Tesla, Inc.
Service Bulletin

Replace AC Junction Box to Fast Charge Contactor HV Harness

SB-25-16-006

December 8, 2025

Figure 1

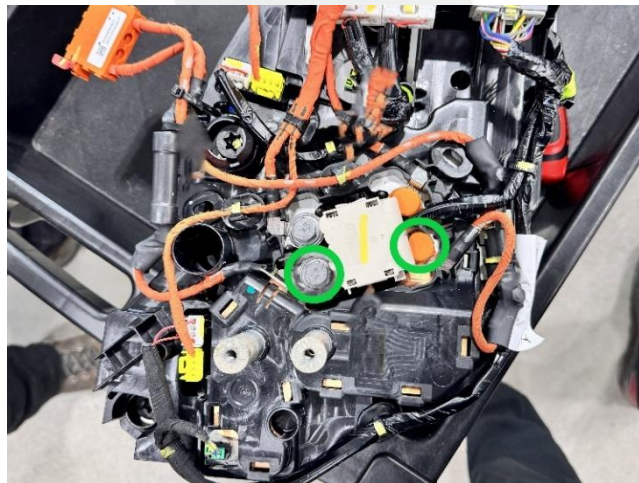
1. Remove the bolts (x2, 13 mm) that attach the AC junction box to fast charge contactor HV harness to the vehicle (Figure 1).

4. Position the new AC junction box to fast charge contactor HV harness into the vehicle.
5. Connect the electrical connectors (x2) and engage the connector lock, and then install the clips (x2) and bolts (5 Nm + 60 degrees) (x2, 13 mm) that attach the harness to the vehicle (Figures 1–4).

Figure 2

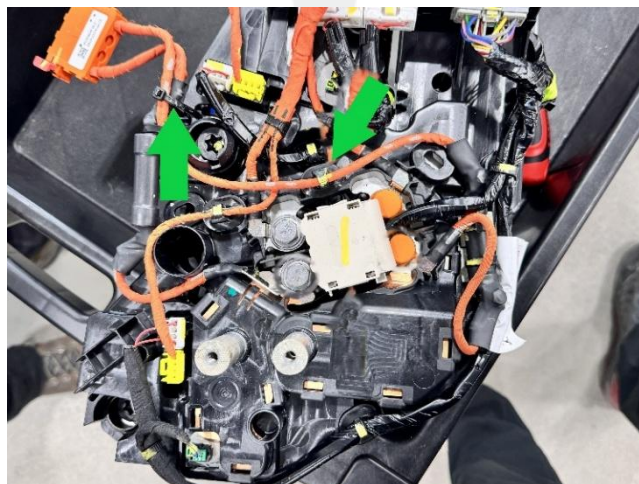
2. Release the clips (x2) that attach the AC junction box to fast charge contactor HV harness to the vehicle (Figure 2).

**NOTE:** Install a new zip tie as needed (Figure 2).

Figure 3

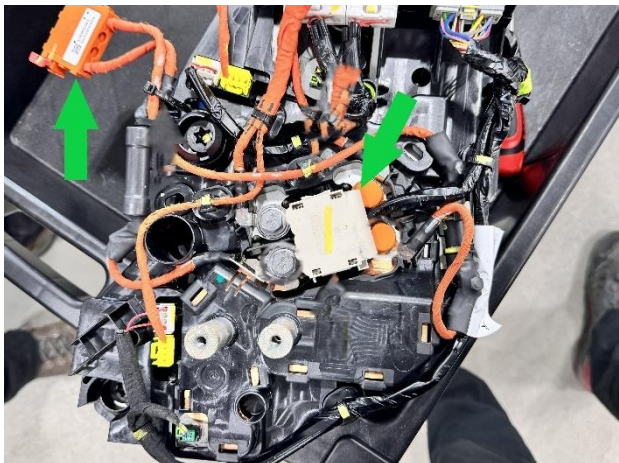
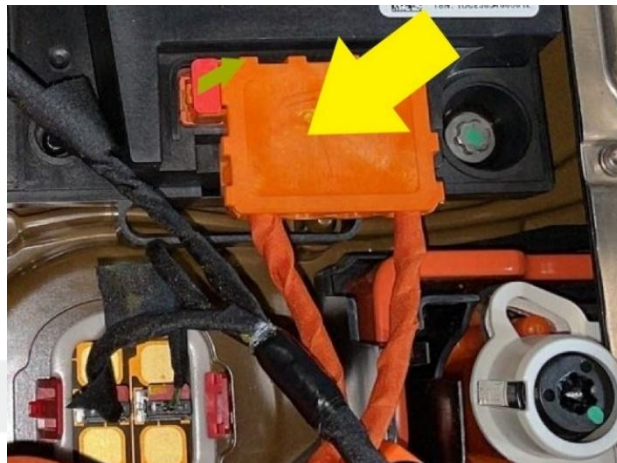
3. Release the red connector lock and disconnect the electrical connectors (x2) (Figures 3 and 4), and then remove the harness from the vehicle.

Figure 5

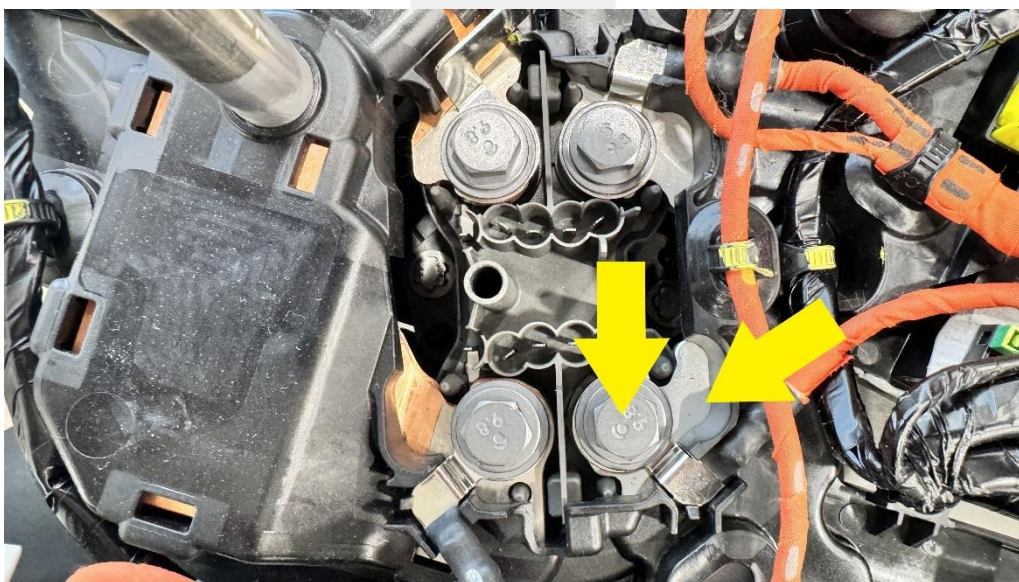
6. Perform a zero adjust to the Hioki meter, and then perform a Hioki impedance measurement at the FC contactor positive joint to positive DC outlet busbar (Figure 5).

**NOTE:** The results of the measurement should be $102\mu\Omega$ or fewer. If the results are greater than $102\mu\Omega$, continue with general diagnosis outside of this bulletin.

Figure 6

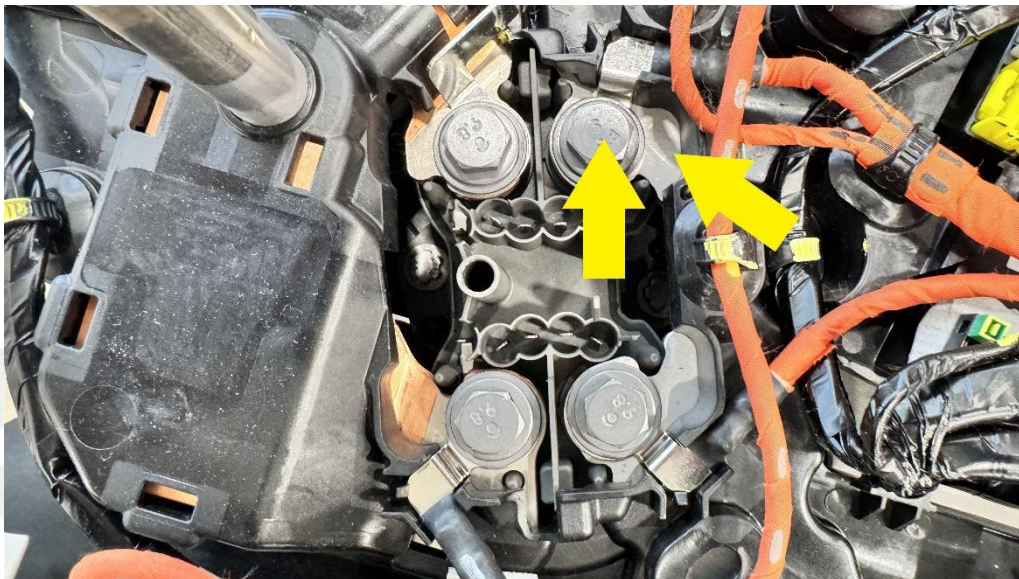
7. Perform a zero adjust to the Hioki meter, and then perform a Hioki impedance measurement at the FC contactor negative joint to negative DC outlet busbar (Figure 6).

NOTE: The results of the measurement should be $102\mu\Omega$ or fewer. If the results are greater than $102\mu\Omega$, continue with general diagnosis outside of this bulletin.
